R.E. Ginna Nuclear Power Plant, LLC

Subject: Response to Request for Additional Information (RAI) dated November 9, 2004,
Regarding the Proposed Control Room Emergency Air Treatment System
(CREATS) Modification
R.E. Ginna Nuclear Power Plant
Docket No. 50-244

REQUEST FOR ADDITIONAL INFORMATION

CONTROL ROOM EMERGENCY AIR TREATMENT SYSTEM

TIME CURRENT CHARACTERISTIC CURVES

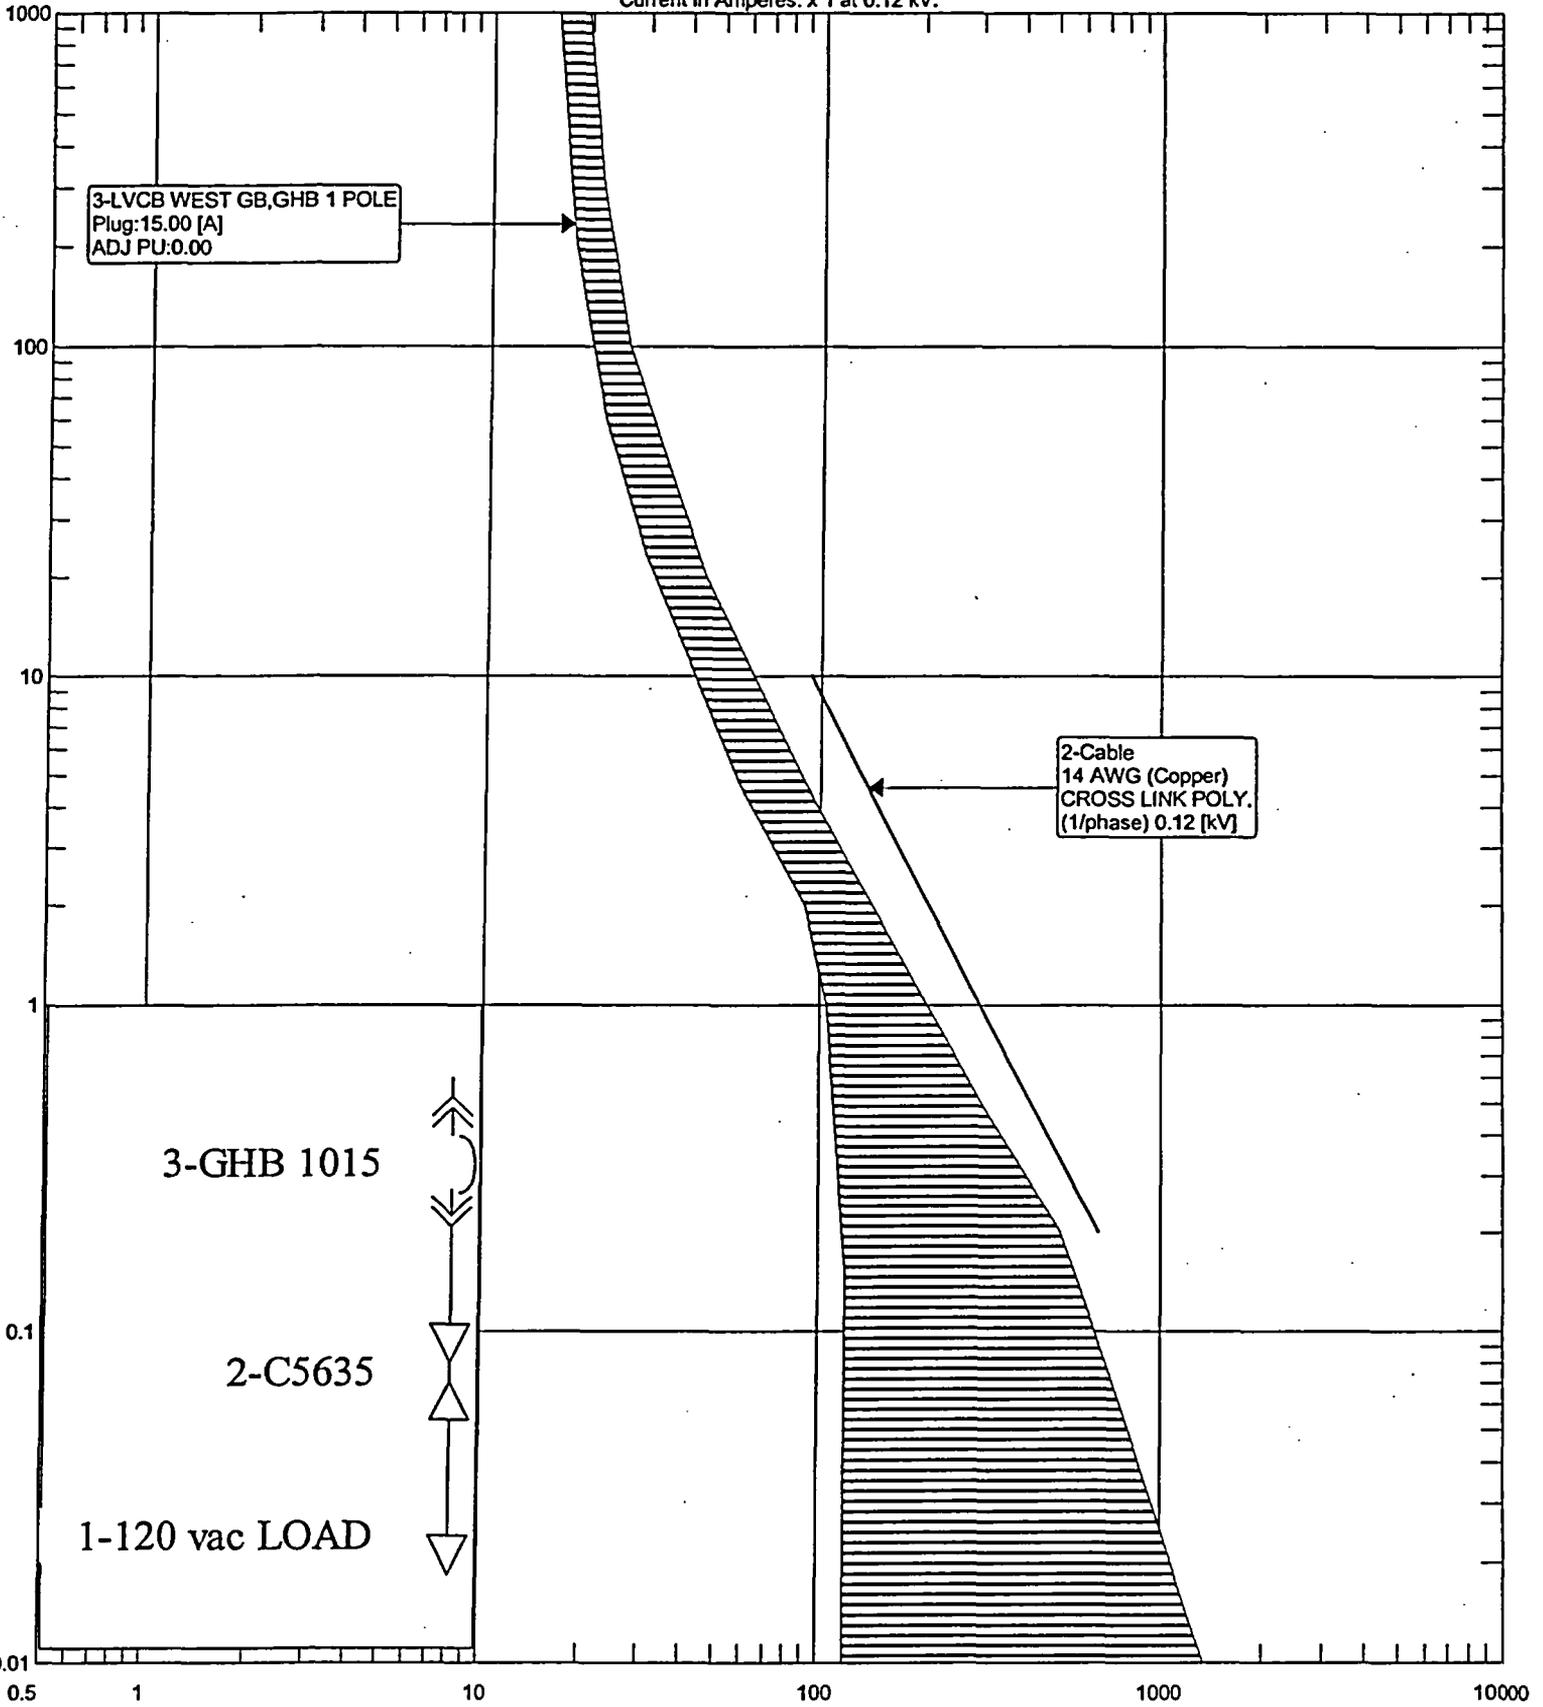
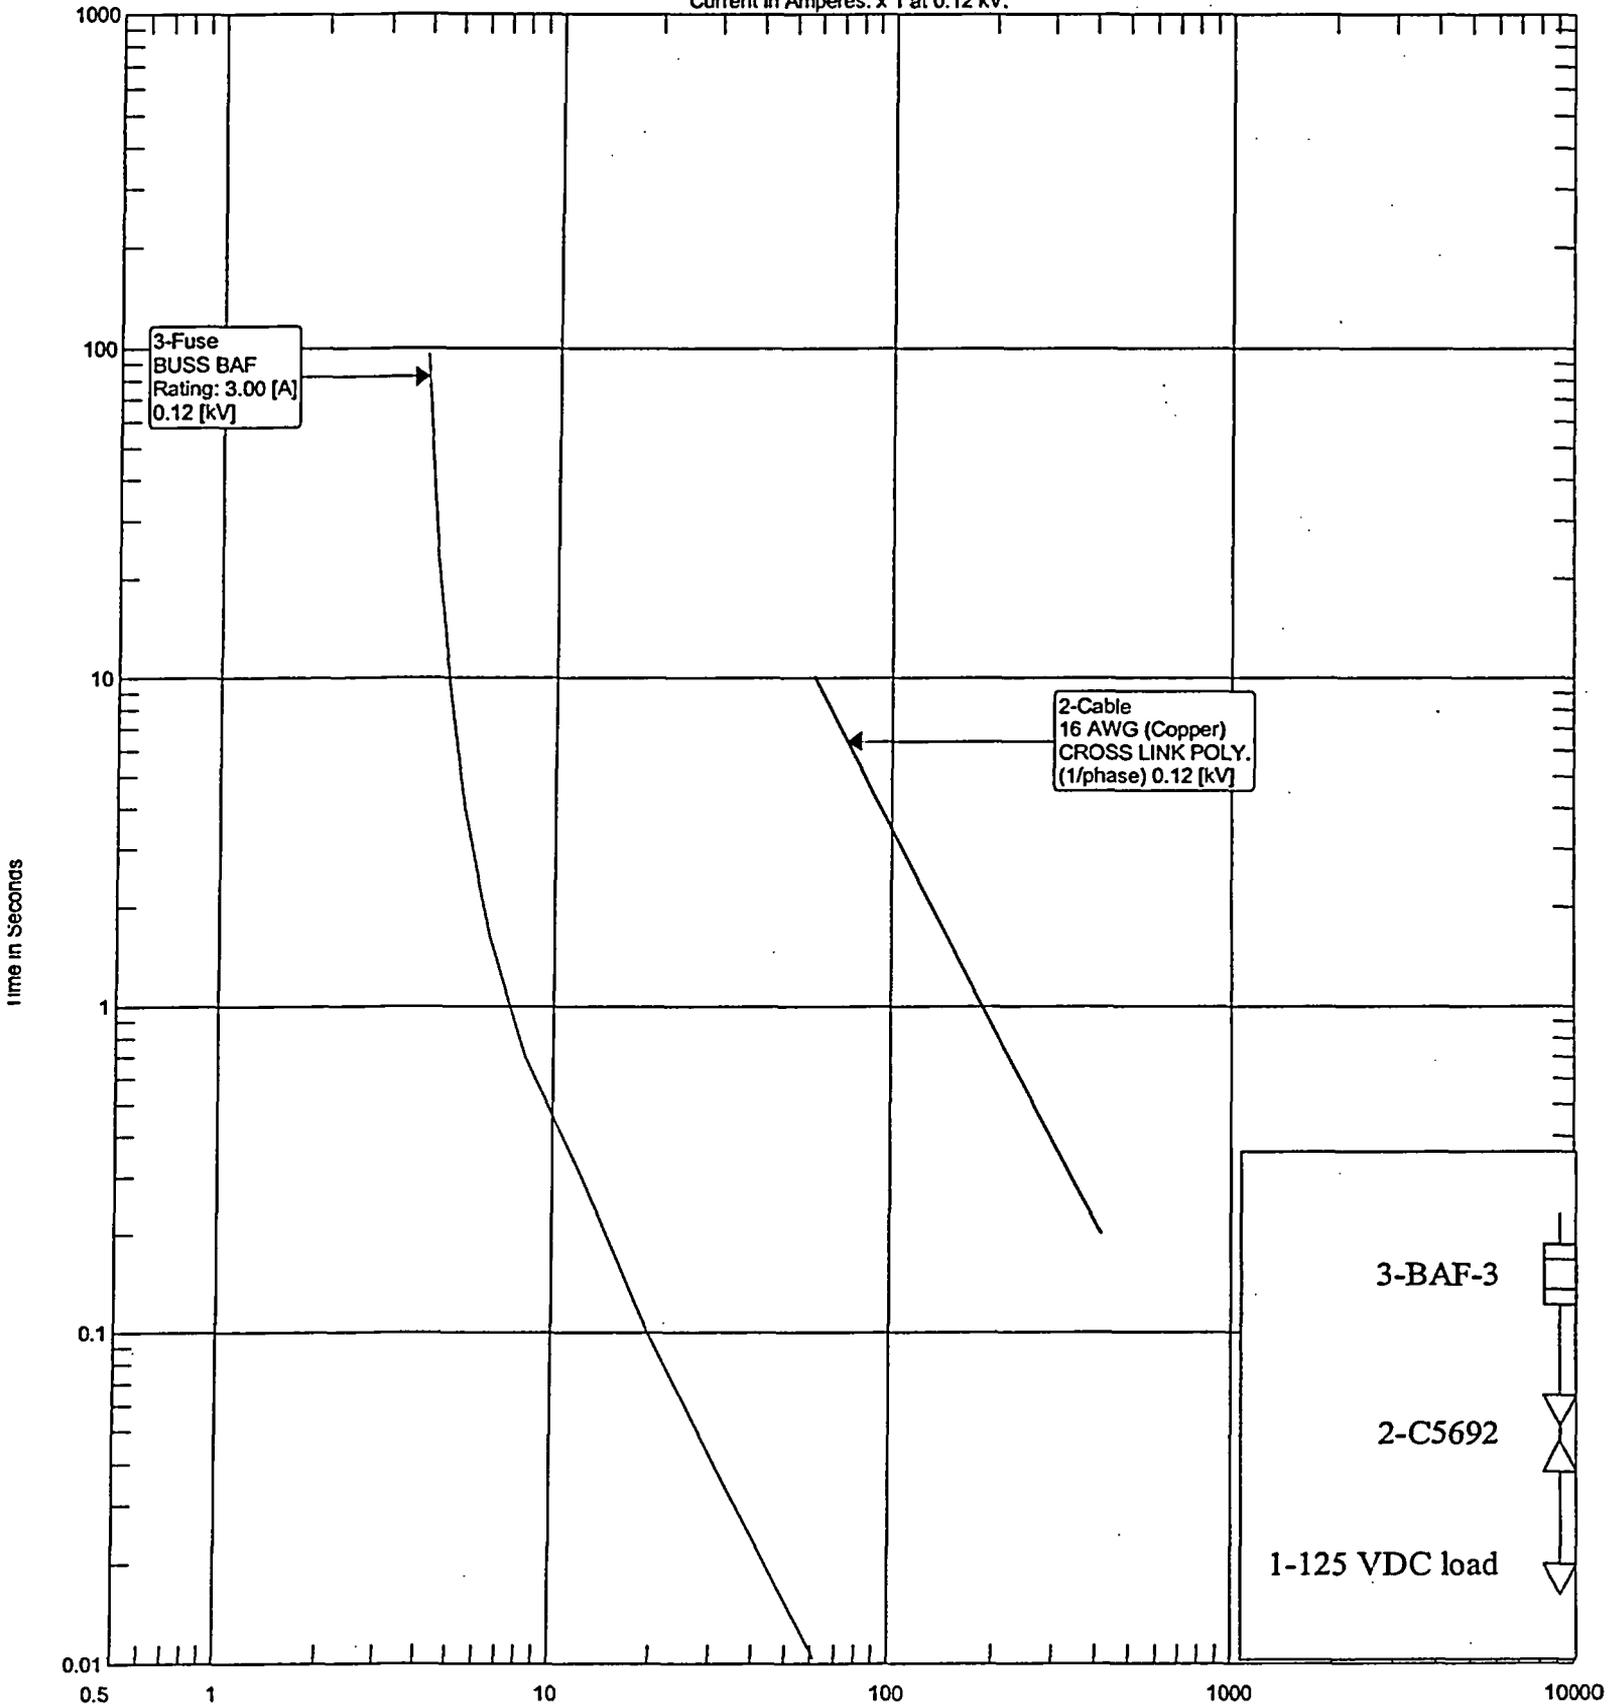
Response to NRC Inquiry Concerning Electrical Separations for CREATS Cables in Tray

Following is a table that lists the trays to be utilized by the CREATS project. A walkdown of these trays in the relay room was performed to verify that the utilized portion of each of these trays is separate. Where the same tray designation is utilized for both trains, the cables for each train will maintain physical separation in the tray so the A and B cables will not be routed together, but utilize separate sections of the trays.

The Ginna design philosophy, since original plant design and during all plant modifications since, has been to implement protection schemes that assure that the fuses and breakers selected for a circuit are sized to protect the cable from damage. The fuse/breaker clearing curves are evaluated to ensure a fault or overload clears before the cable damage curve is reached. The fault protection of all cables being installed for this modification has been analyzed to show that the protective device for each cable will clear any fault before the cable damage curve is reached. Breaker and fuse protection of these circuits has been reviewed. The devices installed for this modification will all be procured and installed Safety Related. This feature ensures that if a cable installed for CREATS faults, that fault will clear before cable damage could cause a tray fire that could spread to the redundant train on any "associated circuit" that may transverse between the two redundant cables. Attached are two representative curves created to evaluate the cable protection of new cables. These represent the circuits with the highest voltage rating and smallest cable size for the circuit in each category installed in trays: a 120 VAC control cable (Circuit Schedule C5635) and a 125 VDC control cable (C5692). Both plots show that the protective device (breaker or fuse) will protect the limiting cable.

EXISTING CABLE ANALYSIS

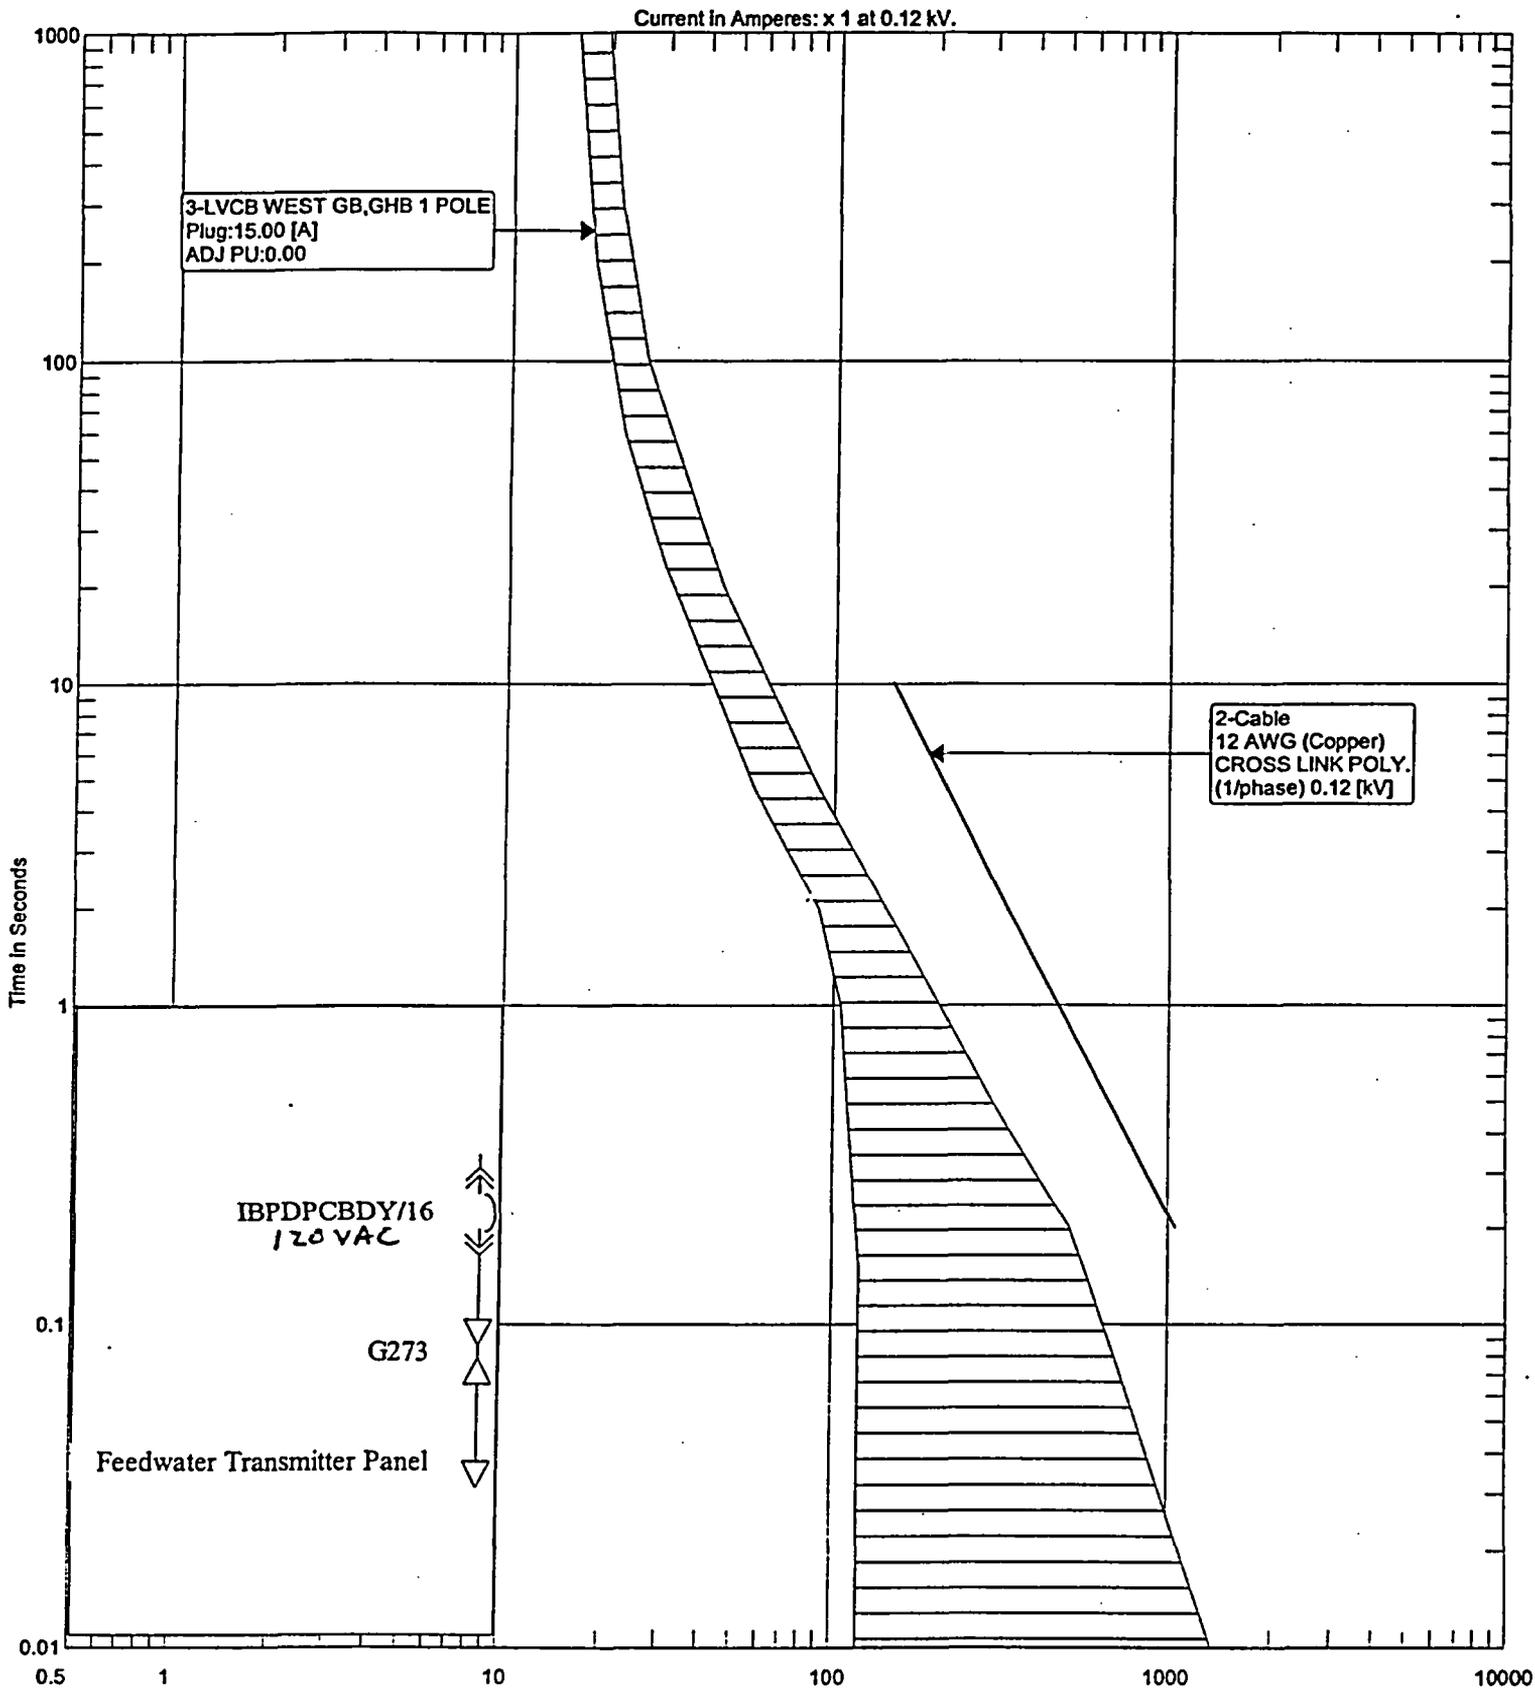
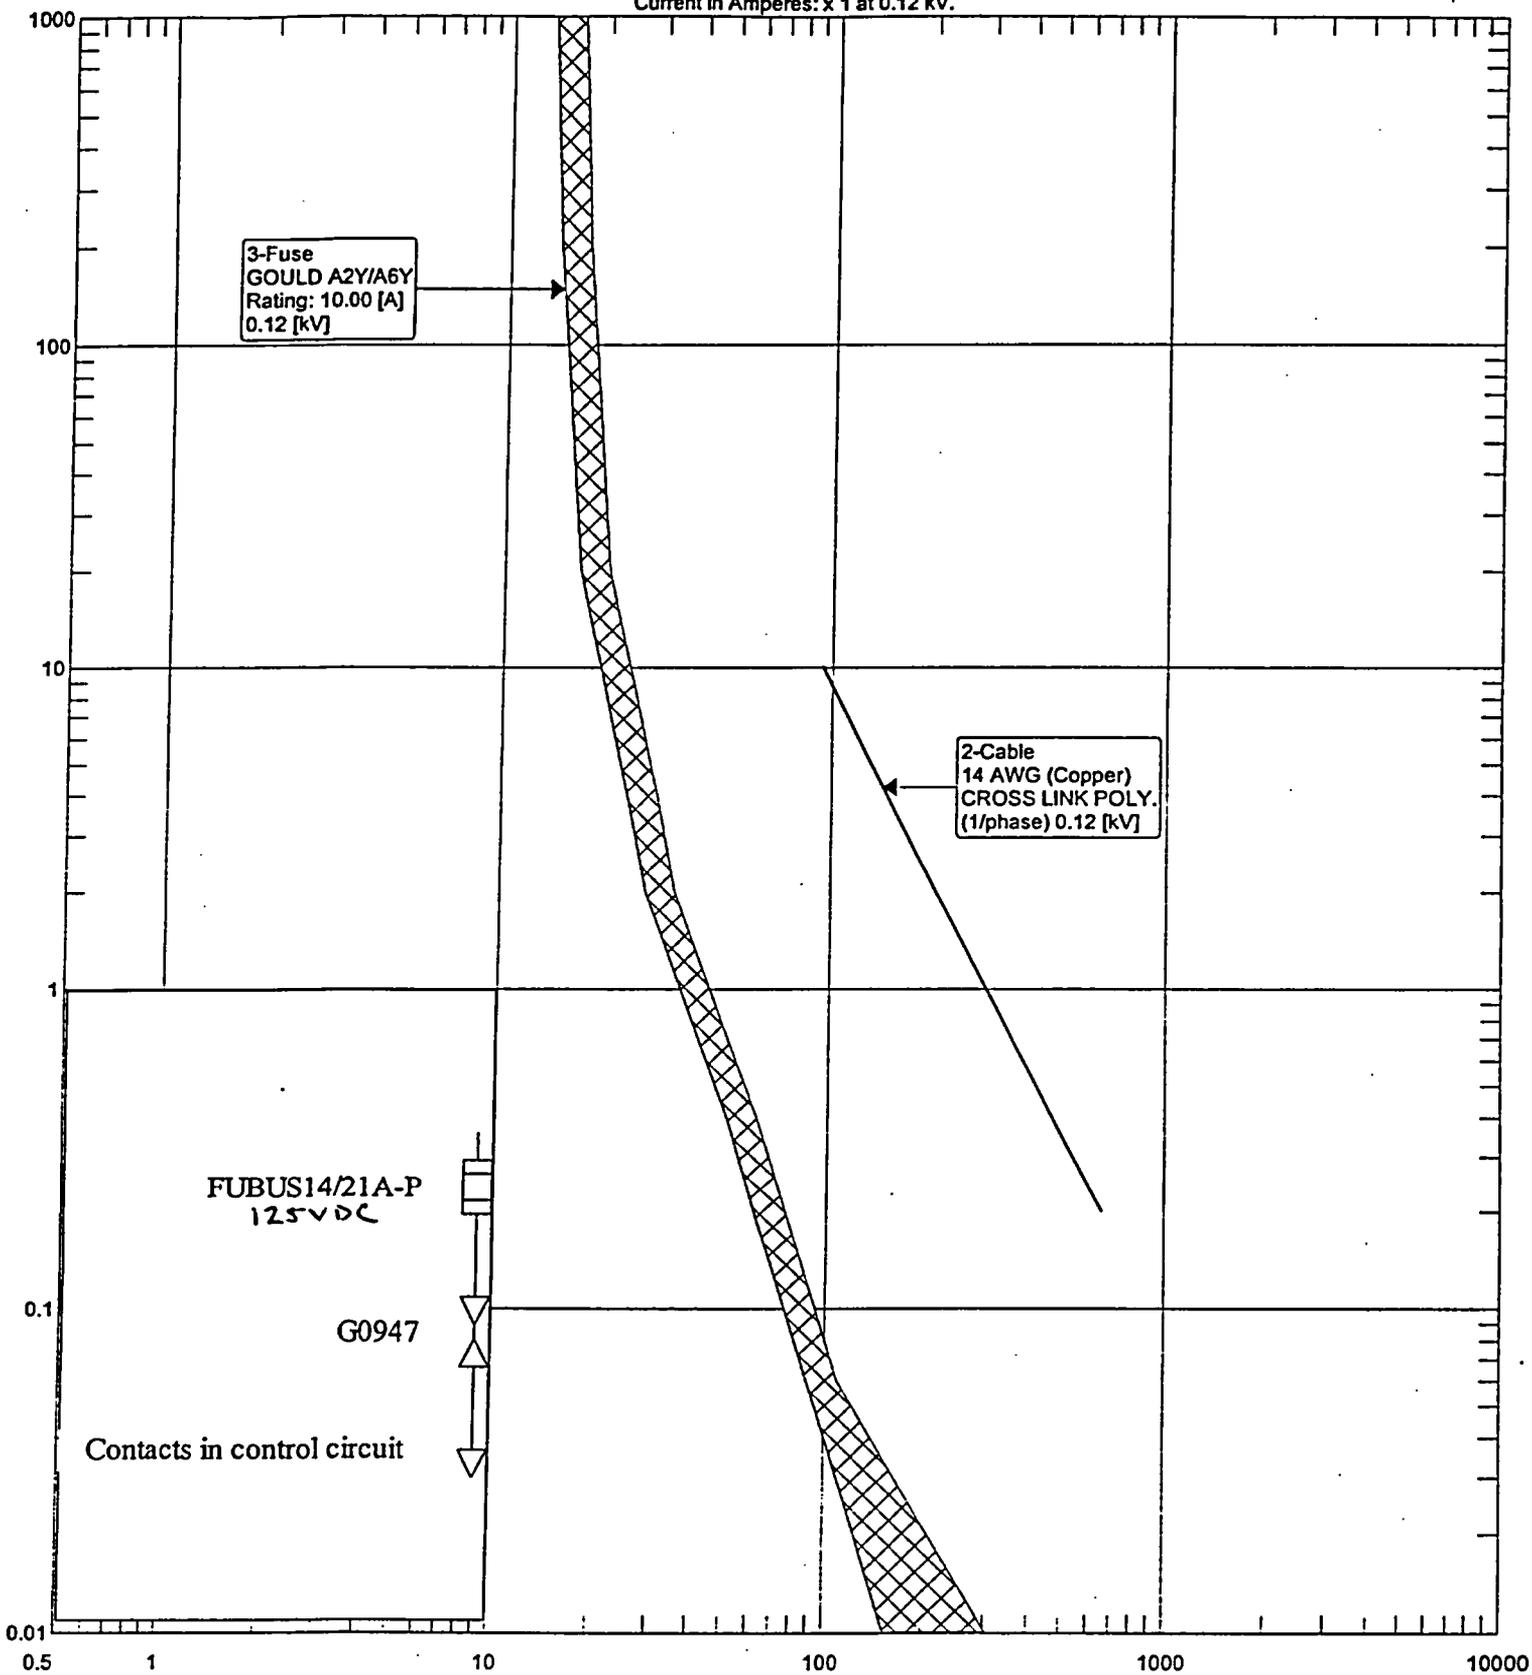
Response:

To provide a reasonable assurance that the existing cables are properly protected, representative pre-existing cables from the trays used for the CREATS modification have been sampled and reviewed to determine the protective device used for fault protection of that cable. Cable damage curves were then created to demonstrate that the protective device is appropriately selected to protect the cable, clearing any fault or overload before cable damage can occur.
